STAFF REPORT: MAY 8, 2024, REGULAR MEETING
APPLICATION NUMBER: HDC2024-00079
ADDRESS: 3844 BAGLEY
HISTORIC DISTRICT: HUBBARD FARMS
APPLICANT: LUZ JANNET AYALA-MORENO
PROPERTY OWNER: LUZ JANNET AYALA-MORENO
DATE OF PROVISIONALLY COMPLETE APPLICATION: MARCH 4, 2024
DATE OF STAFF SITE VISIT: APRIL 23, 2024

SCOPE: ALTER SIDE PORCH (WORK STARTED WITHOUT APPROVAL), REPLACE WINDOWS AND DOORS, INSTALL VINYL SIDING

Left: Proposed Ply Gem single-hung window. Image from product website. Right: Proposed door. Image from product website.

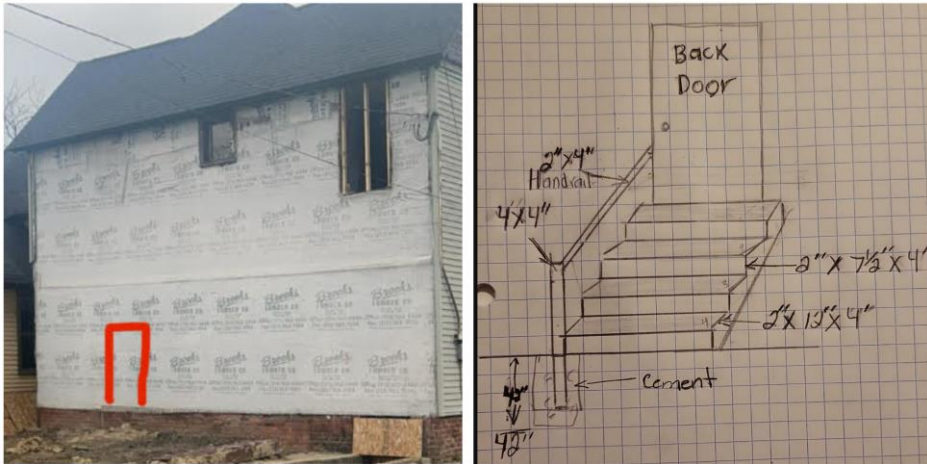
- According to the National Park Service document, *Replacement Windows that Meet the Standards*, non-historic windows are not required to be preserved; if missing, they are not required to be reproduced. Nonetheless, any new windows must be compatible replacements. The proposed windows do not meet this guidance. According to the document, “The stiles of double-hung historic windows align vertically and are the same width at the upper and lower sashes. The use of single-hung windows as replacements may alter this relationship with varying effects on the appearance of a window.” (This condition is illustrated by the image on page 4 of this report). A single-hung window is almost never appropriate on a historic building and is not appropriate in this case.

- The fanlight pattern on the proposed doors is an anachronistic design that is not compatible with the Queen Anne or folk vernacular, circa 1900 design of the building. A somewhat similar door, but either unglazed or

- Replacement of porch elements shall be limited to those that are deteriorated beyond feasible repair; new elements must match the old, subject to approval by staff.
- The first and second floor windows shall be double-hung wood or clad-wood sash windows, subject to approval by staff.
- The basement windows shall be installed according to the Glass Block Guidelines.
- The doors shall be wood or metal panel doors with a rectangular vision panel, or no vision panel, subject to approval by staff.
- The color scheme shall be taken from either Color System A (mid-century vernacular), or Color System B (Queen Anne), but not both; or, another appropriate color scheme may be used subject to approval by staff.

Left: Sketch by applicant showing location of existing rough opening and proposed door. Right: Sketch by applicant of proposed steps. Images from application materials.

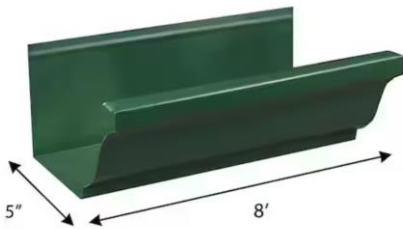
- The removal of the hip-roof rear section (done without approval) dramatically altered the form of the building and eliminated character-defining features, contrary to Standard #2, which requires that “the alteration of features and spaces that characterize a property shall be avoided.”
- Adding siding and a new entrance to the rear (north) elevation of the building is inappropriate in that it furthers and makes permanent a condition (i.e., the removal of the building’s hip-roof rear section) that was created without approval.
- The proposed colors—grey siding, sand windows, and forest green gutters—are individually appropriate; however, when taken together, they create an awkward hybrid between the paler colors of nineteenth-century vernacular architecture and the more saturated tones of the Queen Anne style.

- A plywood porch surface is not compatible with the property; it would also weather quickly and cause additional deterioration.
- The historic windows have not been shown to be beyond repair.
- The proposed work adds historically inappropriate vinyl siding to the building.
- The proposed treatment of the rear elevation (installation of siding, door, and steps) makes permanent an inappropriate alteration that was not approved by the Historic District Commission (i.e., removal of the hip-roof rear section).

Sanborn Map Company 1921. Arrows added to indicate side porch and rear section.

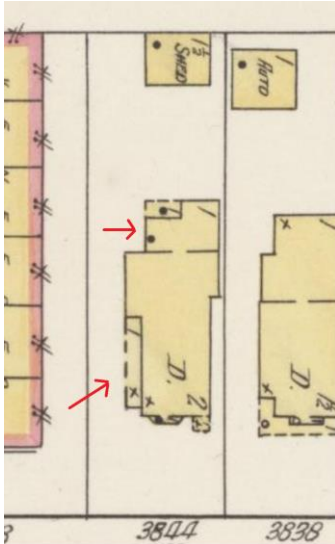
- “Buildings of Victorian substyles also tend to have details of wood located around the entrance, porch, windows, bays, towers, and dormers. Lathe-turned and jigsaw cut wooden elements and details are common.” (*Relationship of architectural details.*)
- As described throughout this report, many exterior features of this building are neither original nor historic. There is no requirement to preserve non-historic features. However, if non-historic features are altered or removed, the new work must be compatible with the building and the district.
- The side porch and now-missing rear section are likely original, as they appear in a 1921 Sanborn map.
